# UNITED STATES PATENT AND TRADEMARK OFFICE

APPLICATION NO.	FILING DATE	FIRST NAMED INVENTOR	ATTORNEY DOCKET NO.	CONFIRMATION NO.
10/699,335	10/31/2003	Anthony J. Caffcrata	J-3763	5399
28165 7590 01/30/2007 S.C. JOHNSON & SON, INC. 1525 HOWE STREET RACINE, WI 53403-2236			EXAMINER FIDEI, DAVID	
			ART UNIT 3728	PAPER NUMBER
SHORTENED STATUTORY PERIOD OF RESPONSE		MAIL DATE	DELIVERY MODE	
3 MONTHS		01/30/2007	PAPER

## Office Action Summary

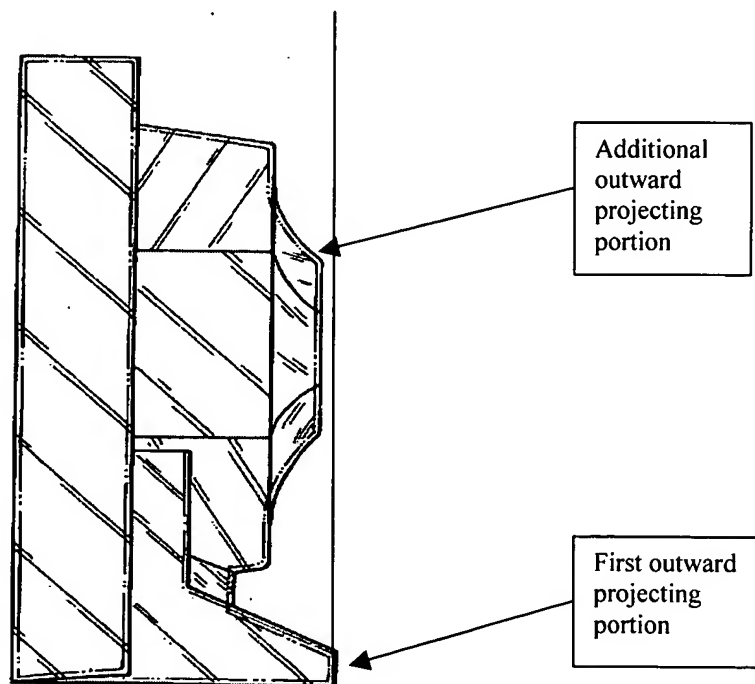
5. Claims 1-4, 7, 8 and 11-14 rejected under 35 U.S.C. 102(b) as anticipated by or, in the alternative, under 35 U.S.C. 103(a) as obvious over Perkins (US Patent no. 4,781,289). As to claims 1, 2, 13 and 14 Perkins discloses a package for containing and displaying at least one article comprising a back panel 12 and a front panel attached to said back panel defining a blister 18. A first outward projecting portion in a bottom portion of the blister is defined by support structure 22 and at least one additional outward projecting portion having a depth and shape conforming to at least a portion of the at least one article is defined by enclosure 20. Col. 3, lines 8-10 states the depth of support structure 22 should be comparable to the depth of product enclosure 20. To the extent that this is not viewed as setting forth a projecting portion 20 equal in depth to a greatest depth in the first outward projecting portion, such a difference would have involved a mere change in the size of a component. A change in size is generally recognized as being within the level of ordinary skill in the art. In re Rose, 105 USPQ 237 (CCPA 1955). Also, it has been held that where the only difference between the prior art device and the claimed device was a recitation of relative dimensions, the claimed device was not patentably distinct from the prior art device, Gardner v. TED Systems, Inc., 725 F.2d 1338, 220 USPQ 777 (Fed. Cir. 1984), cert. Denied, 469 U.S. 830, 2325 USPQ 232 (1984), see M.P.E.P. 2144.04 (IV).

As to claims 3 and 4, the additional outward projecting portion is continuous with the first outward projecting portion in that the blister pack 18 is formed as a unitary member.

As to claims 7 and 8, the first outwardly projecting portion 22 has a front wall of uniform depth relative to surface 15.

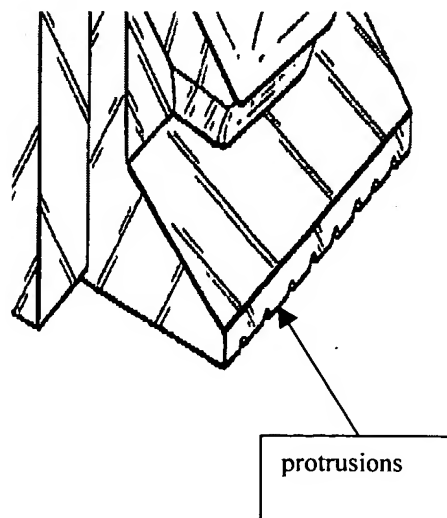
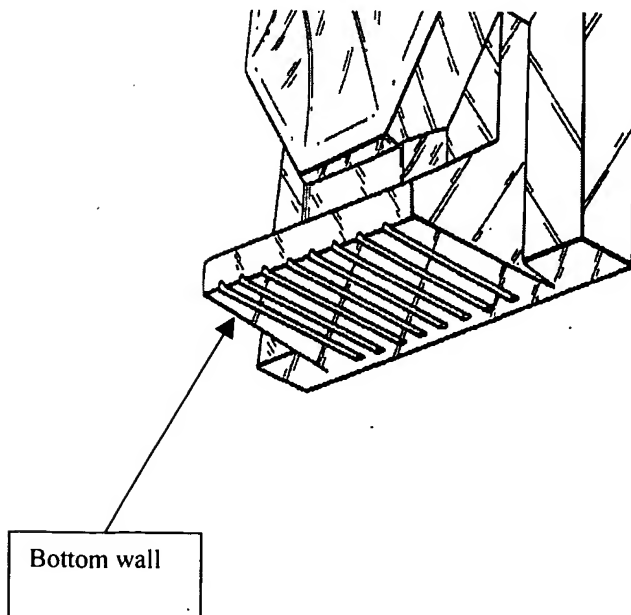
6. Claims 1-12 are rejected under 35 U.S.C. 103(a) as being unpatentable over Humphrey (Patent no. D447,408) in view of Perkins (US Patent no. 4,781,289). Humphrey (Patent no. D447,408). As to claims 1 and 2 a package for containing and displaying at is disclosed comprising a back panel, and a front panel attached to said back panel, wherein said front panel

comprises a blister pack formed of plastic and including a first outward projecting portion in a bottom portion of said blister pack and at least one additional outward projecting portion having a depth and shape conforming to at least a portion of said at least one article, wherein at least a portion said first outward projecting portion extends widthwise at least a substantial portion between a first side of said blister pack and a second side of said blister pack, and has a depth outward sufficient to allow said package to stand substantially upright. As shown by the figure below the depth of said at least a portion of said first outward projecting portion is greater than an outermost projecting portion of the depth of said at least one additional outward projecting portion.

The difference between claims 1, 2 and Humphrey resides in the depth of the first portion equal to a greatest depth of an outermost projecting portion of the additional outward portion.

Perkins Col. 3, lines 8-10 states the depth of support structure 22 should be comparable to the depth of product enclosure 20. It would have been obvious to one of ordinary skill in the art to modify Humphrey by constructing the first portion equal to a greatest depth of an outermost projecting portion of the additional outward portion as suggested by Perkins, in to provide a self supporting package while not making the base excessively deep.

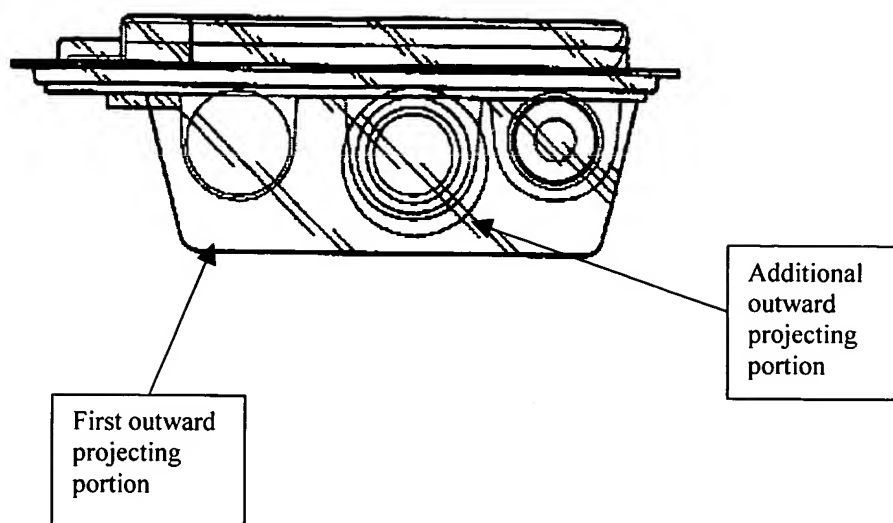
As to claim 5, a package according to claim 1 wherein said first outward projecting portion includes a bottom wall having integral therein at least two spaced apart downward protrusions, see the figure below

As to claim 6, a blister pack is shown according to claim 2 wherein said first outward projecting portion includes a bottom wall having integral therein at least two spaced apart downward protrusions. As shown above there are a plurality of protrusions in as much as is claimed.

**FIG. 1**

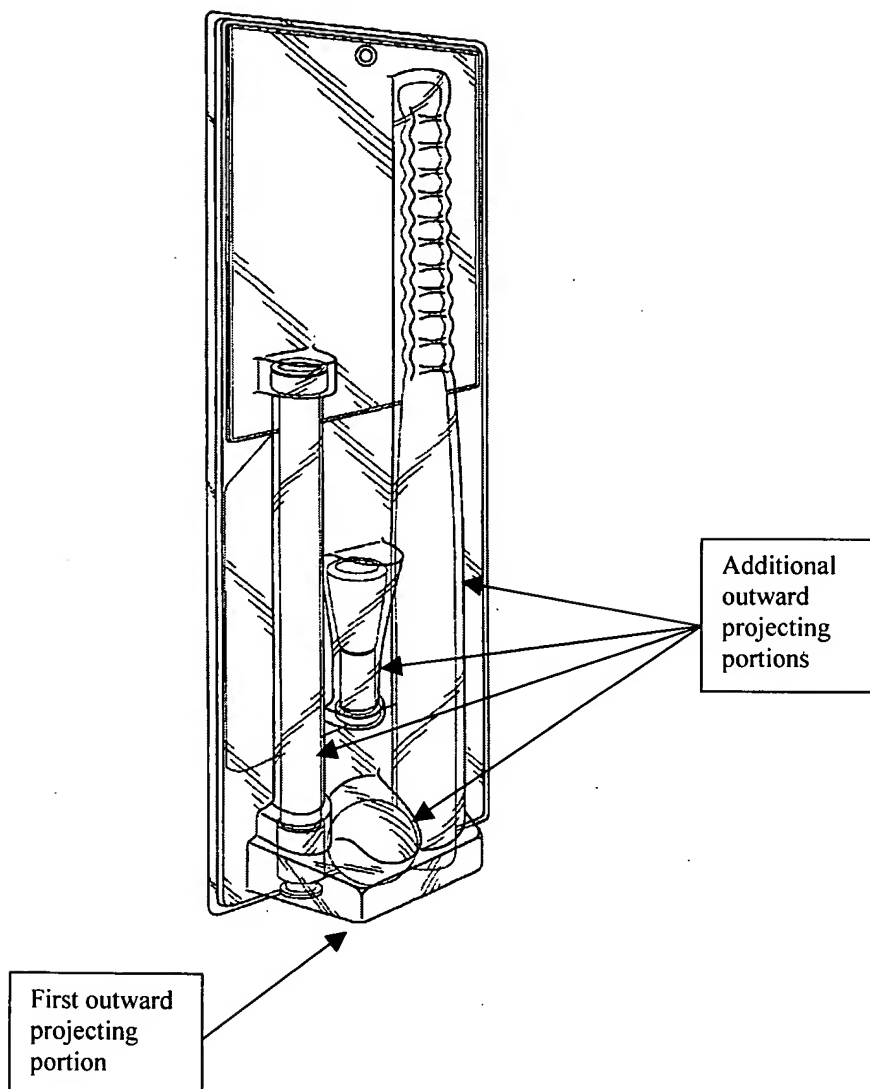
7. Claims 1-4, 7-12, 15 and 16 are rejected under 35 U.S.C. 103(a) as being unpatentable over Udwin et al (Patent no. D467,494) in view of Perkins (US Patent no. 4,781,289) Udwin et al (Patent no. D467,494). As to claims 1 and 2 a package for containing and displaying at is disclosed comprising a back panel, and a front panel attached to said back panel, wherein said front panel comprises a blister pack formed of plastic and including a first outward projecting portion in a bottom portion of said blister pack and at least one additional outward projecting portion having a depth and shape conforming to at least a portion of said at least one article, wherein at least a portion said first outward projecting portion extends widthwise at least a substantial portion between a first side of said blister pack and a second side of said blister pack, and has a depth outward sufficient to allow said package to stand substantially upright. As shown by the figure below the depth of said at least a portion of said first outward projecting portion is greater than an outermost projecting portion of the depth of said at least one additional outward projecting portion.

The difference between claims 1, 2 and Udwin resides in the depth of the first portion equal to a greatest depth of an outermost projecting portion of the additional outward portion. Perkins Col. 3, lines 8-10 states the depth of support structure 22 should be comparable to the depth of product enclosure 20. It would have been obvious to one of ordinary skill in the art to modify Humphrey by constructing the first portion equal to a greatest depth of an outermost projecting portion of the additional outward portion as suggested by Perkins, in to provide a self supporting package while not making the base excessively deep.

As to claims 3 and 4, a package is shown above according to claims 1 and 2 wherein said at least one additional outward projecting portion is continuous with said first outward projecting portion.

As to claim 15 and 16, a package is shown in the figure where said at least one additional outward projecting portions are present, on either side of the middle additional projection portion, wherein said two of said at least two additional outward projecting portions are of different depths from each other.
